STATE OF MAINE
DEPARTMENT OF TRANSPORTATION
16 STATE HOUSE STATION
AUGUSTA, MAINE 04333-0016

March 21, 2014
Subject: **Augusta Phase 2**
State Project No: 020118.20
Amendment No. 1

Make the following change to the Bid Documents:

SKS-11
AMENDMENT #1

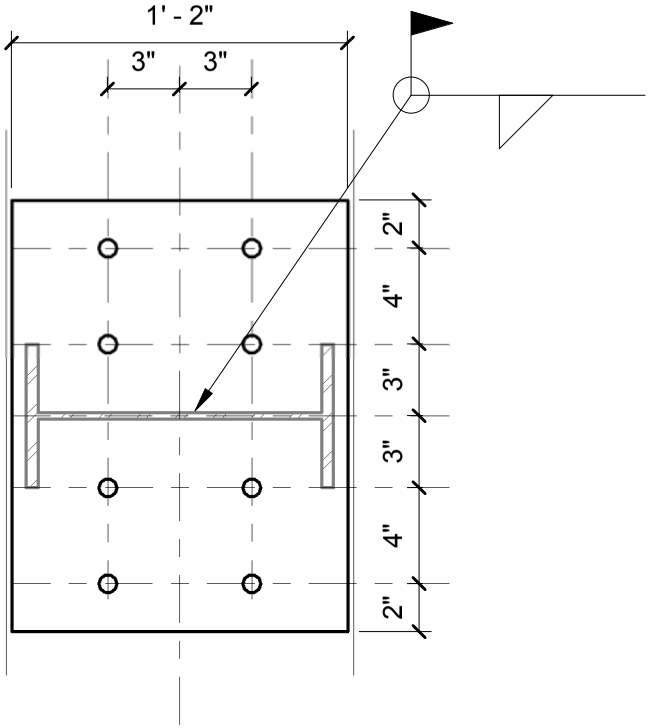
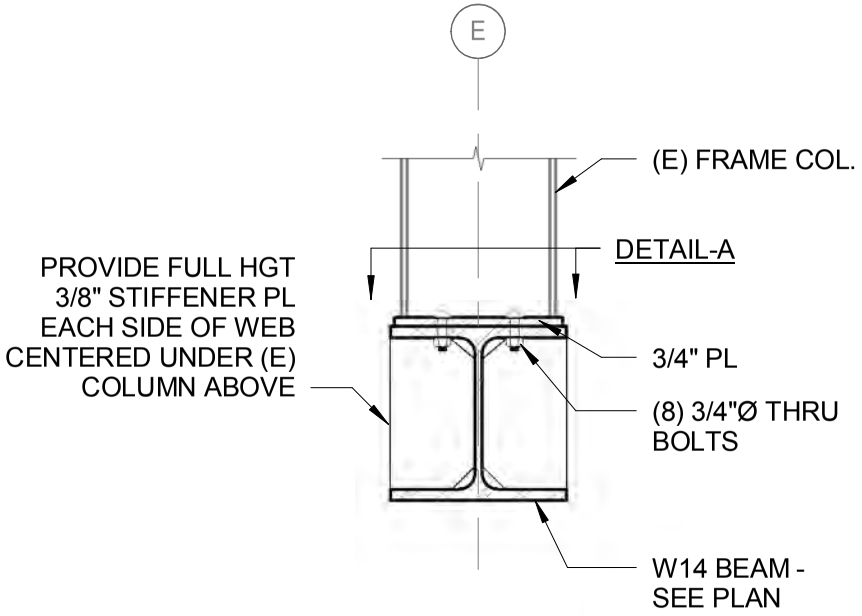
On plan Sheet SF501 Titled "STRUCTURAL - DETAILS"
ADD: DETAIL A7 – DETAIL AMENDMENT-1 SKETCH SKS-11

SKS-12
AMENDMENT #1

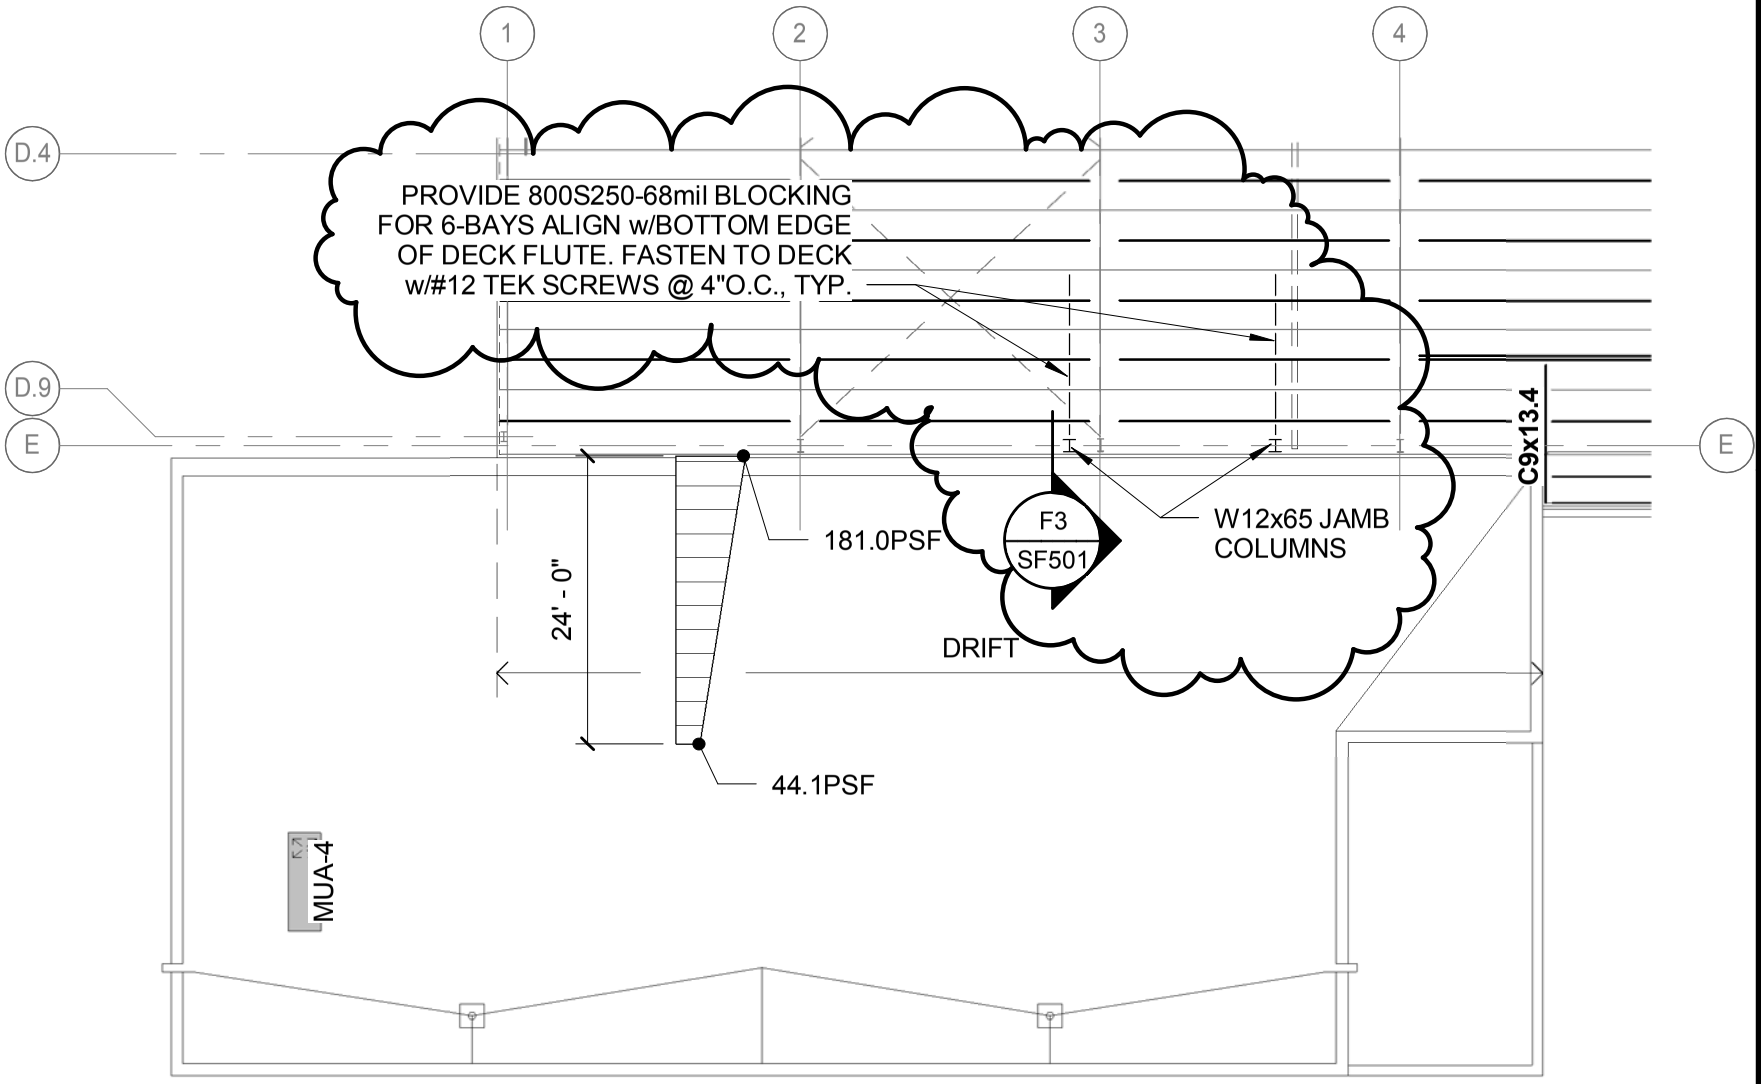
On plan Sheet SF101 Titled “STRUCTURAL – ROOF FRAMING PLAN”
ADD: BLOCKING TIGHT TO UNDERSIDE OF ROOF DECK FOR 6-BAYS AT TOP OF W12X65 JAMB COLUMNS ALONG LINE-E BETWEEN LINES 2 AND 4.

PROVIDE CAP PLATES UNDERSIDE OF ASSUMED (E) ROOF PERIMETER BEAM AMENDMENT-1 SKETCHES SKS-12 AND SKS-13

SKS-14
AMENDMENT #1

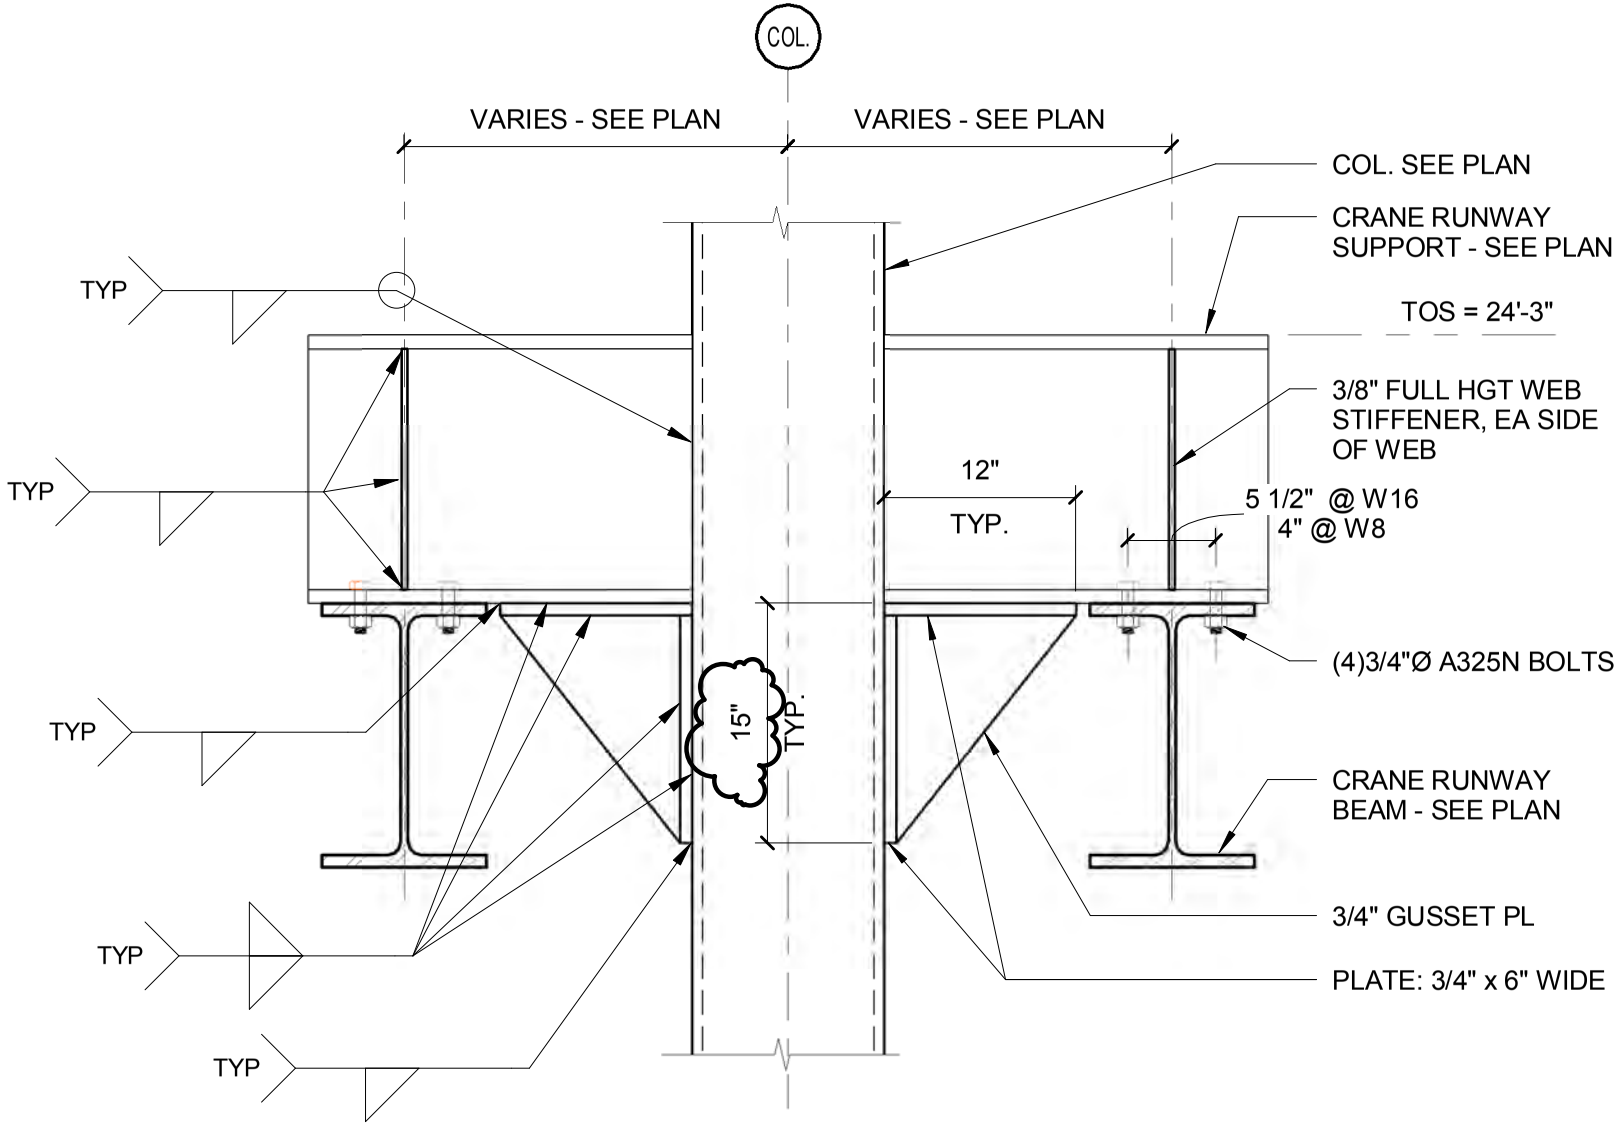
On plan Sheet SF502 Titled "STRUCTURAL – DETAILS"
DELETE: DETAIL A4 - TYPICAL DETAIL AT CRANE SUPPORT FRAMING
ADD: DETAIL A4. AMENDMENT-1 SKETCH SKS-14

USE THIS DETAIL AT ALL CRANE COLUMN LOCATIONS EXCEPT FOR THE FOLLOWING:

[LINE D.88 @ 2.8, 3.6]
LINE 3.6 @ C.71, D.01, D.51]
[LINE C.4 @ 3.8]
LINE B.9 @ 6]
[LINE A.22 @ 6.2]

SKP-01
AMENDMENT #1

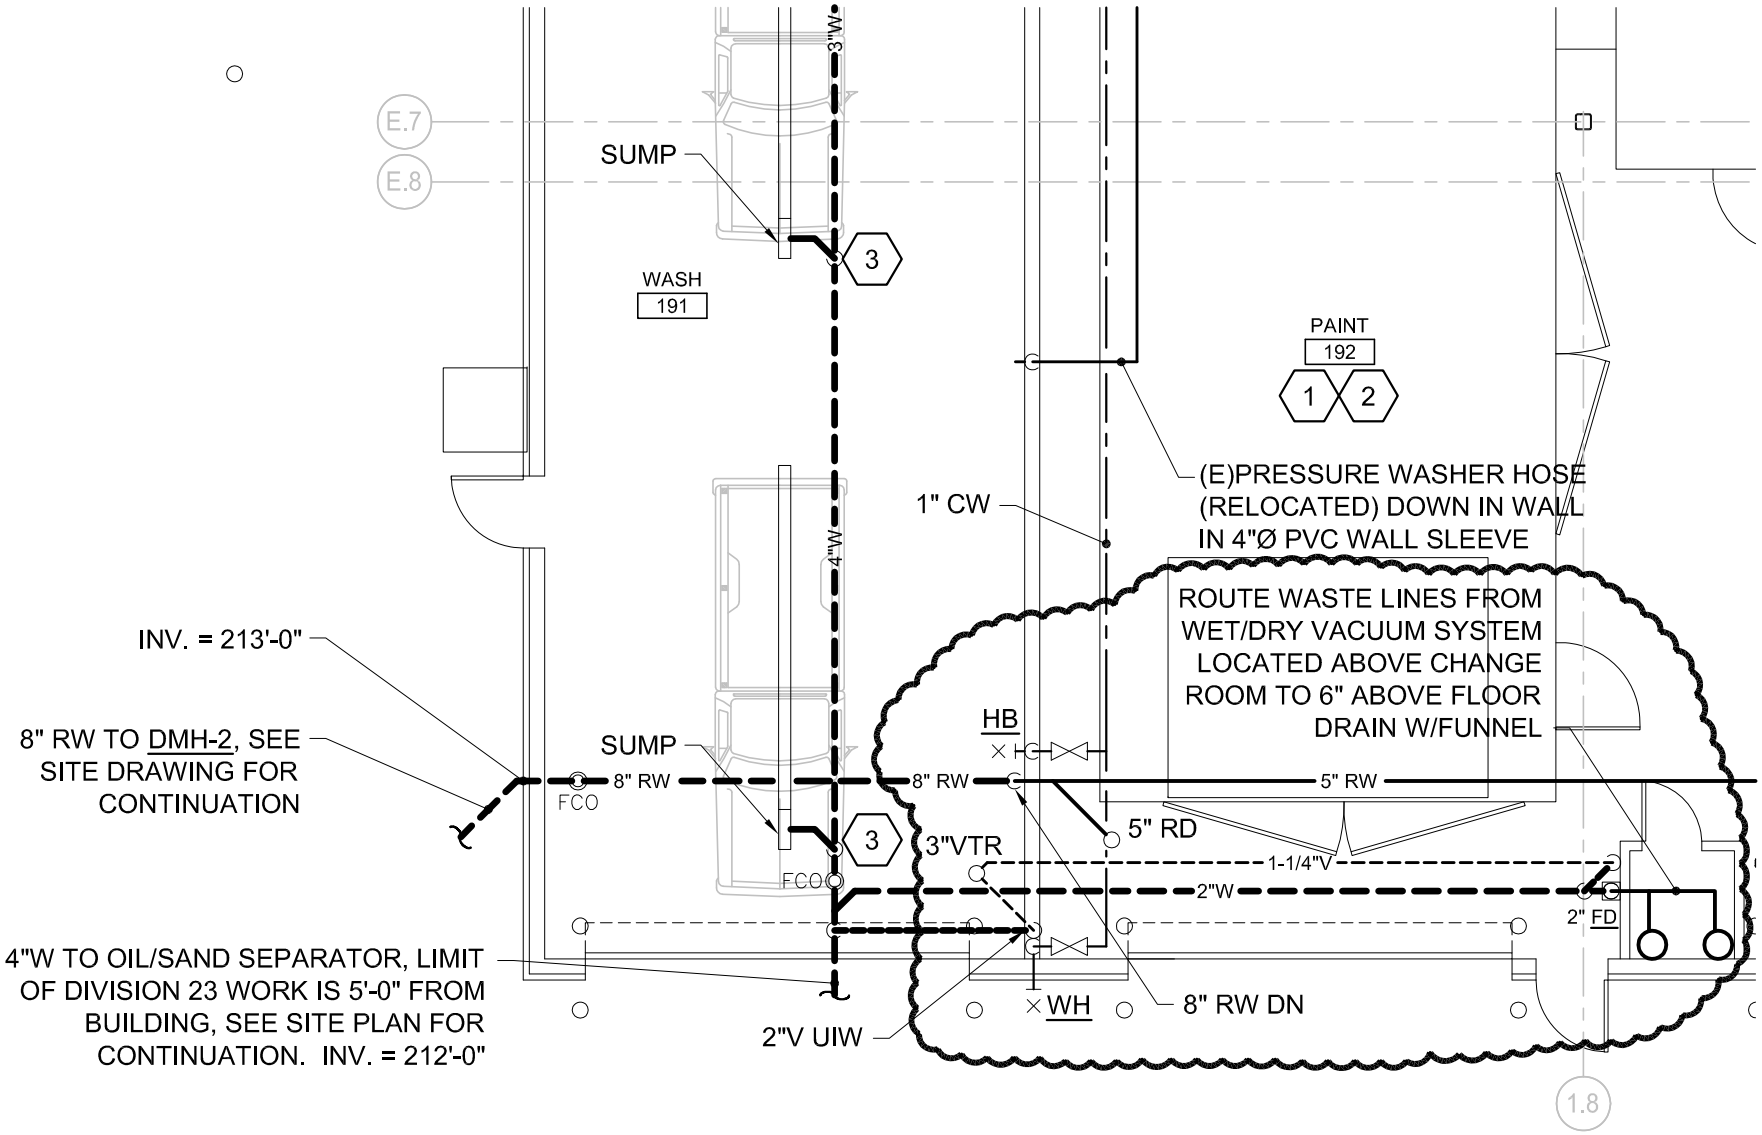
On plan Sheet PL100C Titled Plumbing Part Plan First Floor – Area C, **REVISE** drawing per SKP-01 (Relocated Wet/Dry Vacuum System).

RELOCATED WET/DRY VACUUM SYSTEM
~ C1 - SHEET PL100C

SKP-02
AMENDMENT #1

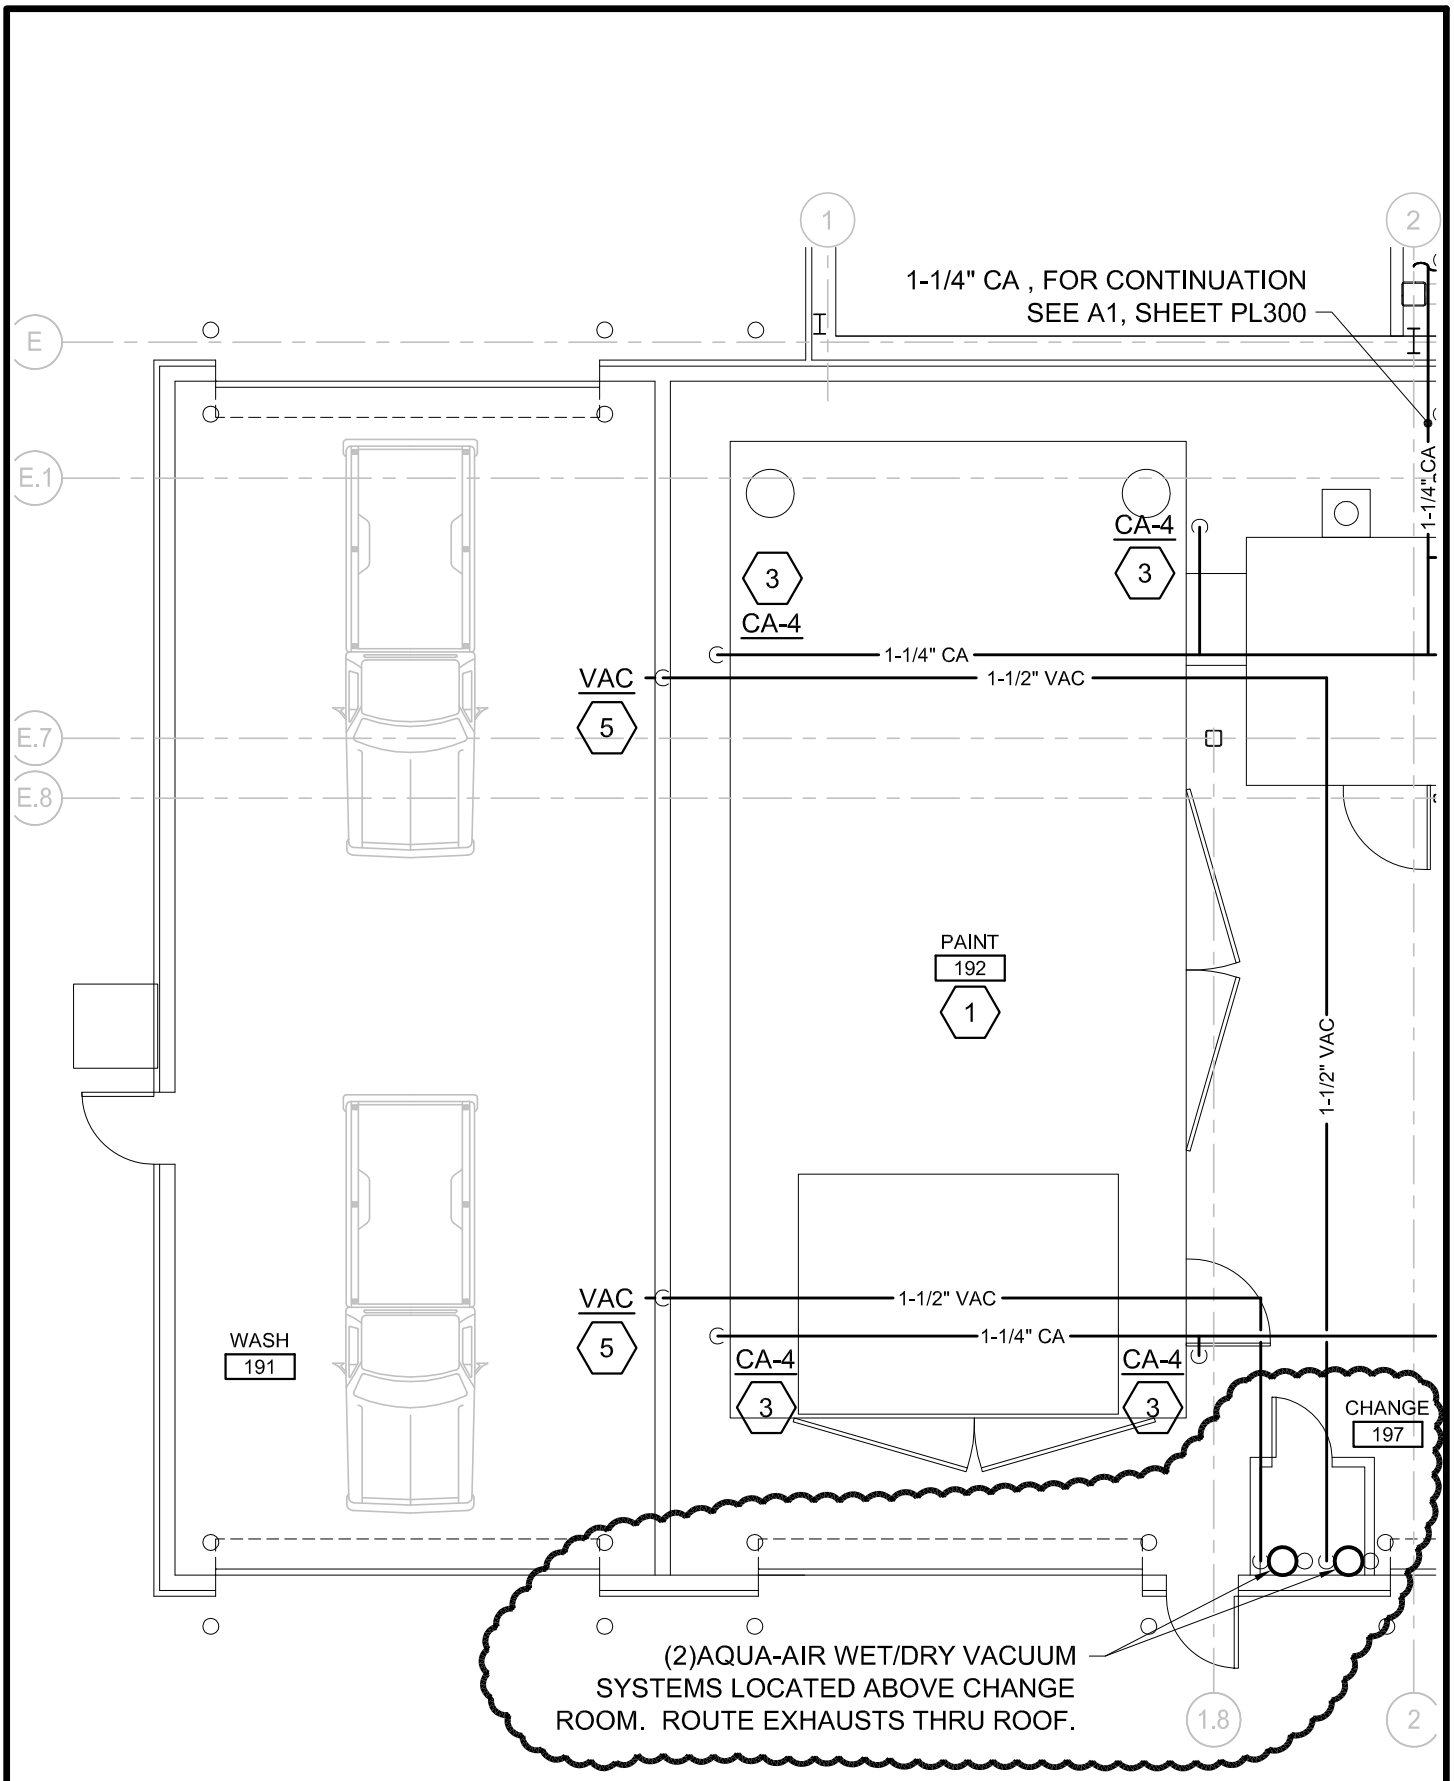
On plan Sheet PL301 Titled Compressed air/ Vacuum Part Plan and Details, **REVISE** drawing per SKP-02 (Relocated Wet/Dry Vacuum System).

RELOCATED WET/DRY VACUUM SYSTEM
~ A3 - SHEET PL301
